SUBJECT: Request for Alternative ANO1-PT-001
Response to a Request for Additional Information

Arkansas Nuclear One, Unit 1
Docket No. 50-313
License No. DPR-51

**REVISED FIGURES 1 AND 2 FOR
REQUEST FOR ALTERNATIVE ANO1-PT-001**

FIGURE 1

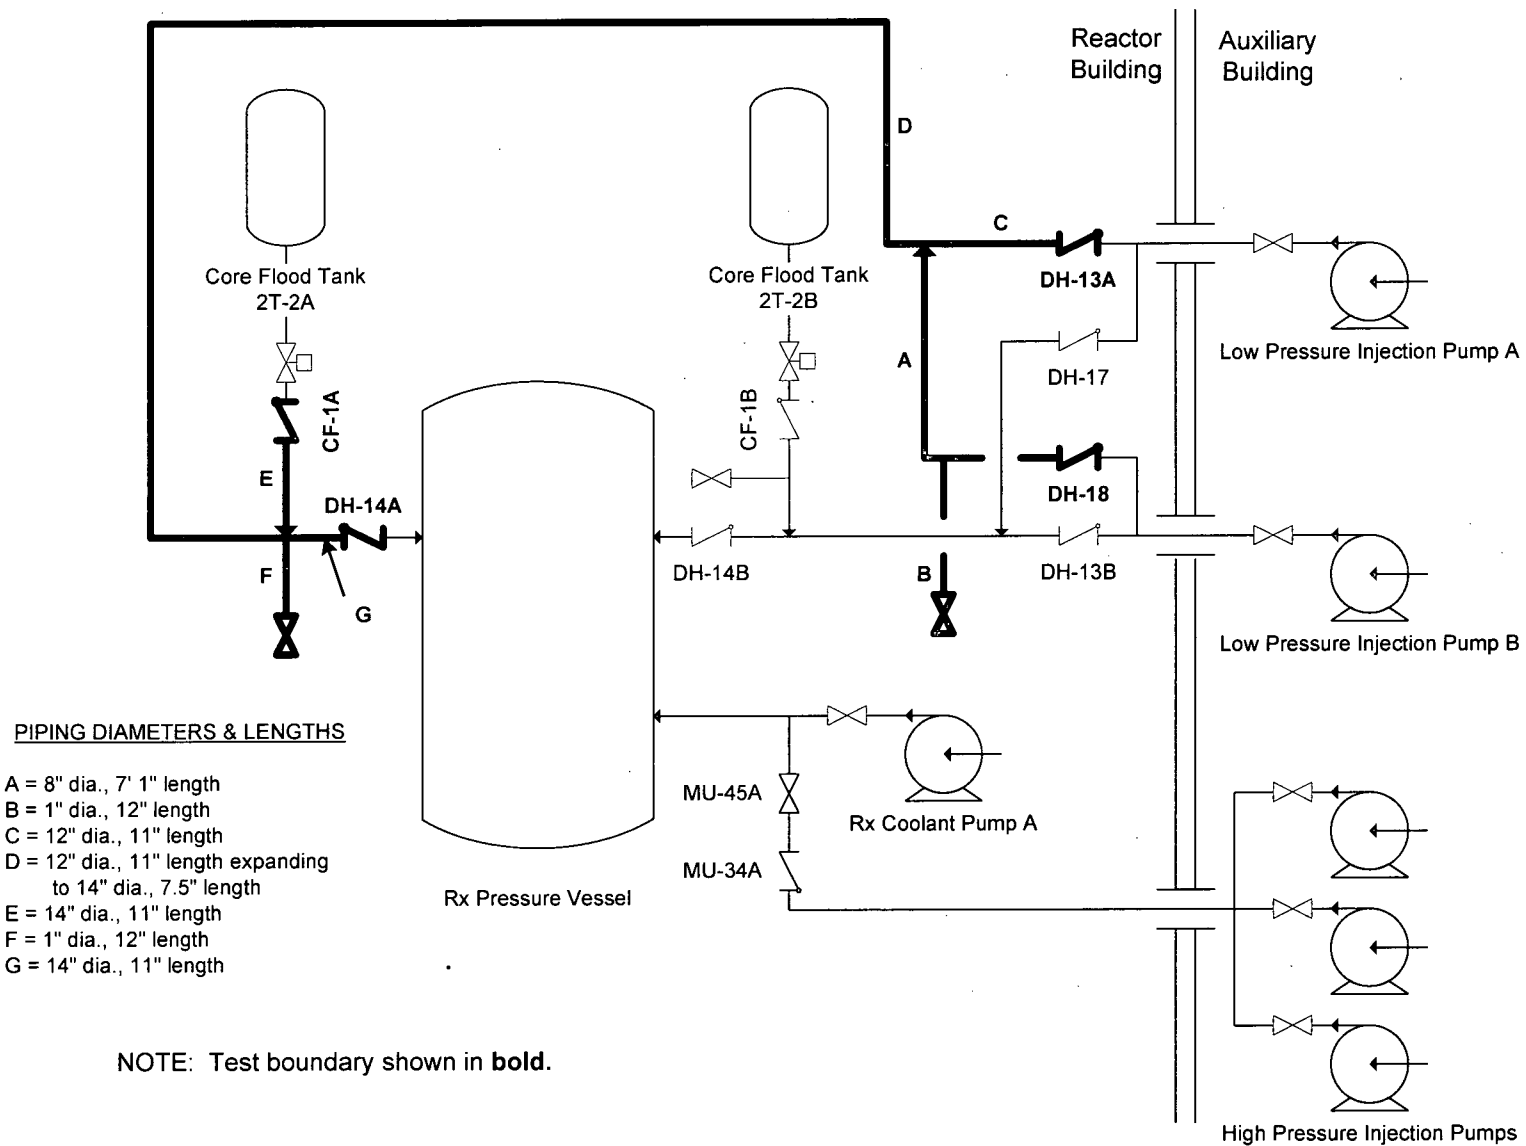
In the referenced letter, Entergy Operations, Inc. (Entergy) submitted to the NRC staff Request for Alternative ANO1-PT-001, which requests approval to visually examine the extended reactor coolant pressure boundary (RCPB) piping between the first and second normally closed isolation valves during the Class 2 system leakage test conducted each inspection interval as an alternative to ASME Section XI IWB-5222(b). In a recent telephone conversation regarding the request, the NRC requested that additional information be provided; specifically, the dimensions for the piping associated with Decay Heat Removal Loops "A" and "B".

In response to this request for additional information, Entergy has enclosed revised Figures 1 and 2 from ANO1-PT-001 that provide the requested information. These figures replace those previously contained in the referenced letter.
